Quality Audit Response Document

Kishoge/Clonburris, Lot 2, Site 4

KSG4-CSC-ZZ-XX-RP-C-0008

Stage 1 Quality Audit

Figure 5.2 – Vehicle movements on pedestrian areas

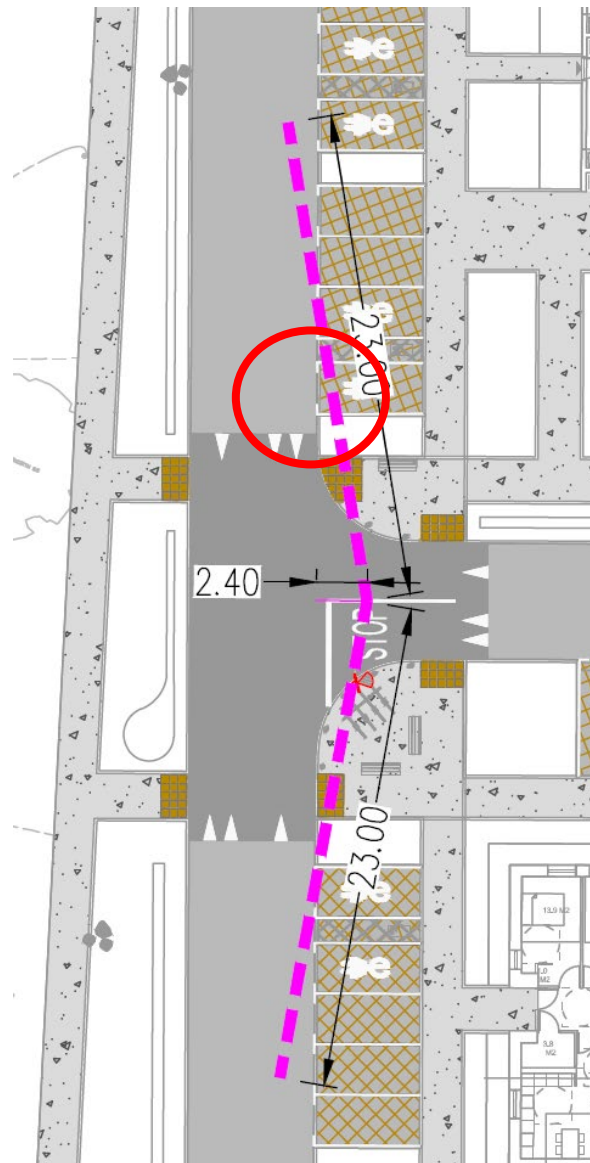
5.4 **Issue**

Some visibility splays, while annotated on drawings, may be compromised by formal parking. This may increase the risk of vehicular collisions at this location due to compromised sightlines.

Ensure adequate visibility splays.

2.1.12 Response to Item 5.4

Adequate visibility splays shall be provided throughout the development, where formal parking significantly impacted the proposed visibility splay, parking has been relocated. The proposed visibility splays are provided on CS Consulting drawing no. **KSG4-CSC-XX-XX-DR-C-0028**.

Figure 6.1 – Reduced Intervisibility between pedestrians and motorists

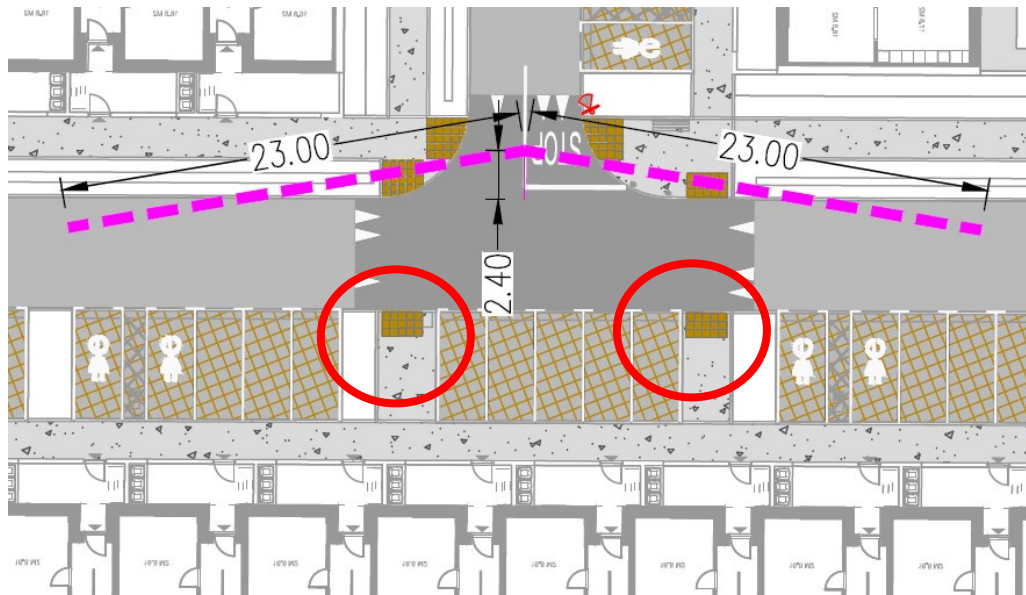
6.4 **Issue**

Pedestrian crossings at certain locations may be compromised by parked vehicles and may compromise intervisibility between pedestrians and motorists, potentially causing injuries.

Ensure adequate intervisibility between pedestrians and motorists at all locations.

2.2.12 Response to Item 6.4

The proposed locations of pedestrian crossings have been reviewed in relation to the proposed intervisibility between pedestrians and motorists. Buffer strips have been provided between the pedestrian crossing locations and proposed car parking. Please refer to CS Consulting drawing no. **KSG4-CSC-XX-XX-DR-C-0011**.

Figure 8.1 – Raised Table Area

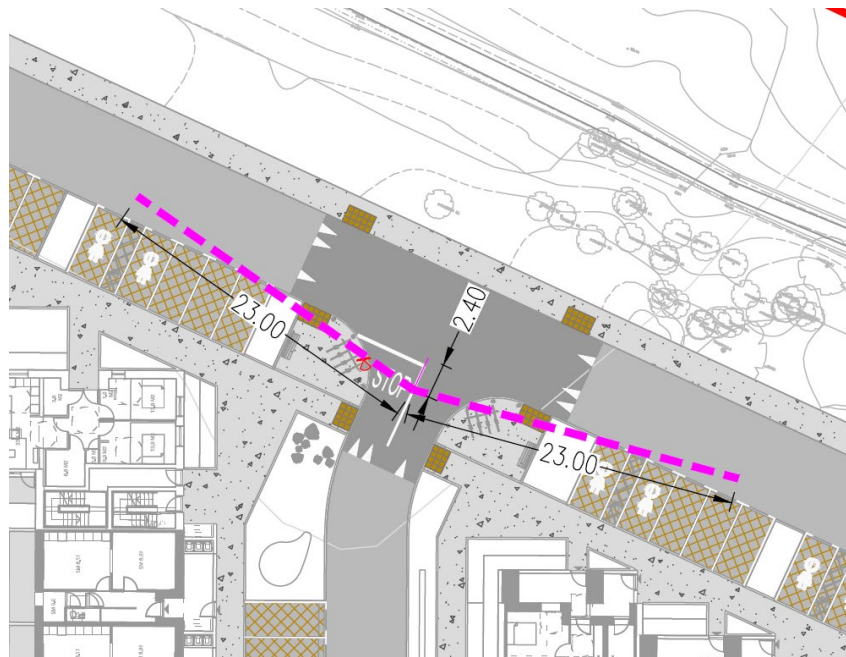
8.2 Issue

It is unclear if raised carriageways will have a kerb separation between carriageways and footways. This may create a hazard between pedestrians and vehicles, especially where white cane users can't distinguish footways from carriageways and where footways terminate at carriageways. Mobility impaired pedestrians may also struggle at crossings proposed at tie-ins to vehicular grade changes.

Ensure adequate separation and crossing points between pedestrians and vehicles.

2.4.6 Response to Item 8.2

A kerb upstand (typically 50mm) shall be provided at raised table junctions. This upstand shall be transitioned to flush at proposed pedestrian crossing locations and appropriate tactile paving shall be provided.

Figure 8.2 – Car charging bays

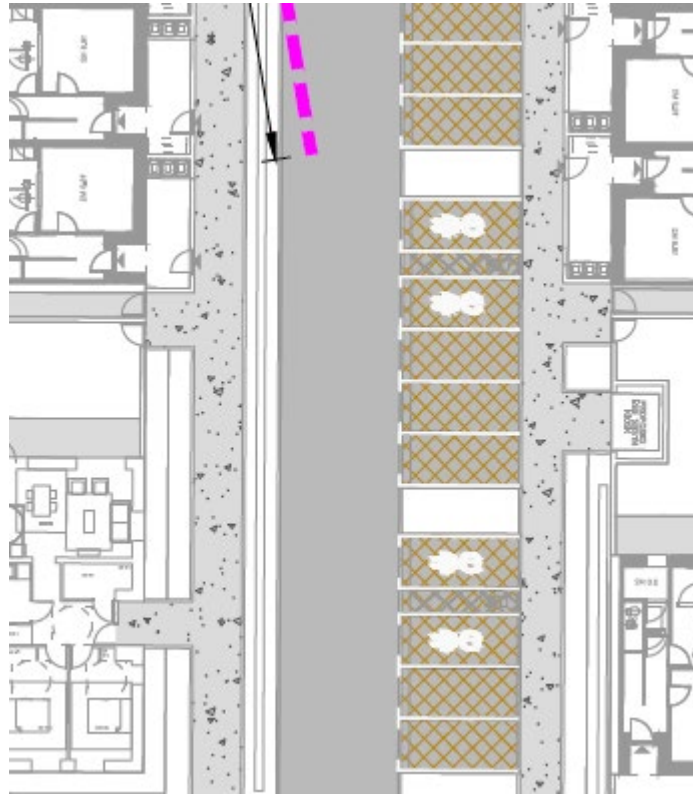
8.4 Issue

Some electric charging bays have been provided. It is unclear how the chargers will connect the vehicles and if a tripping hazard will be generated for pedestrians.

Ensure arrangement of charging infrastructure does not generate a tripping hazard.

2.4.12 Response to Item 8.4

EV charging car parking spaces have been provided with a buffer strip to contain the proposed charging infrastructure, thereby ensuring that the proposed charging infrastructure does not generate a tripping hazard.

Figure 8.3 – Parking bays adjacent to Raised Table

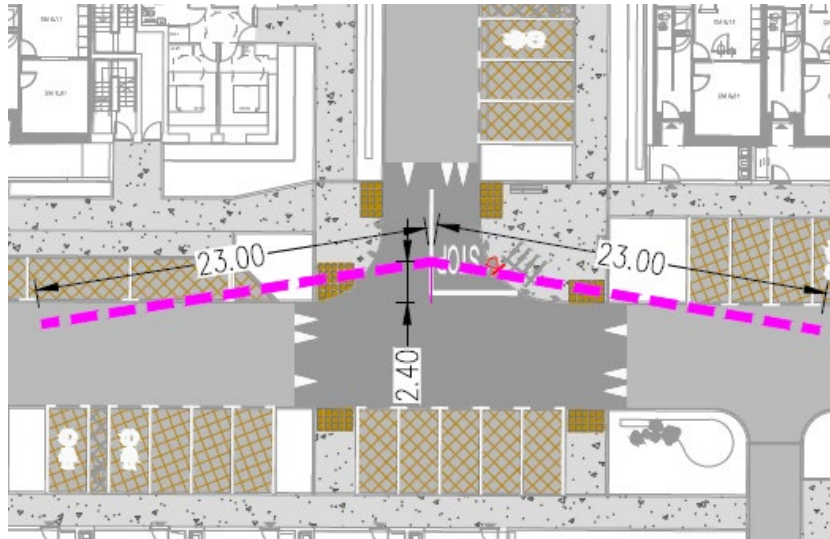
8.5 Issue

Some parking bays are proposed adjacent to Raised Tables. It is unclear if these are to be grade separated from the carriageway or not. This may create a hazard between pedestrians and vehicles, especially where white cane users can't distinguish footways from carriageways and where footways terminate at carriageways.

Ensure adequate separation between pedestrians and vehicles.

2.4.15 Response to Item 8.5

Raised kerbs shall be provided between footways and car parking bays.

Figure 8.3 – Disabled Parking bay

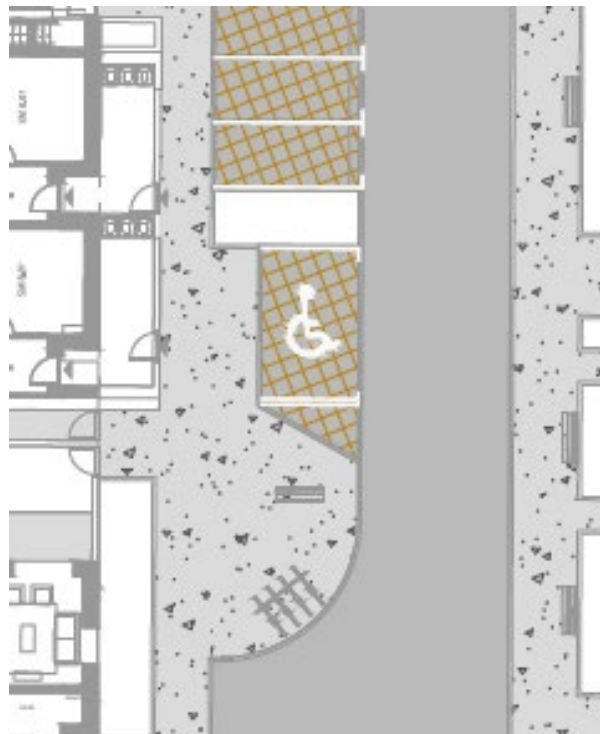
8.6 Issue

Some proposed disabled bays may pose challenges for mobility impaired users accessing/egressing their vehicles as there is no proposed access to pathways around them.

Ensure adequate footway access around the perimeter of each disabled bay.

2.4.18 Response to Item 8.5

Dropped kerbs shall be provided at each disabled car parking bay.
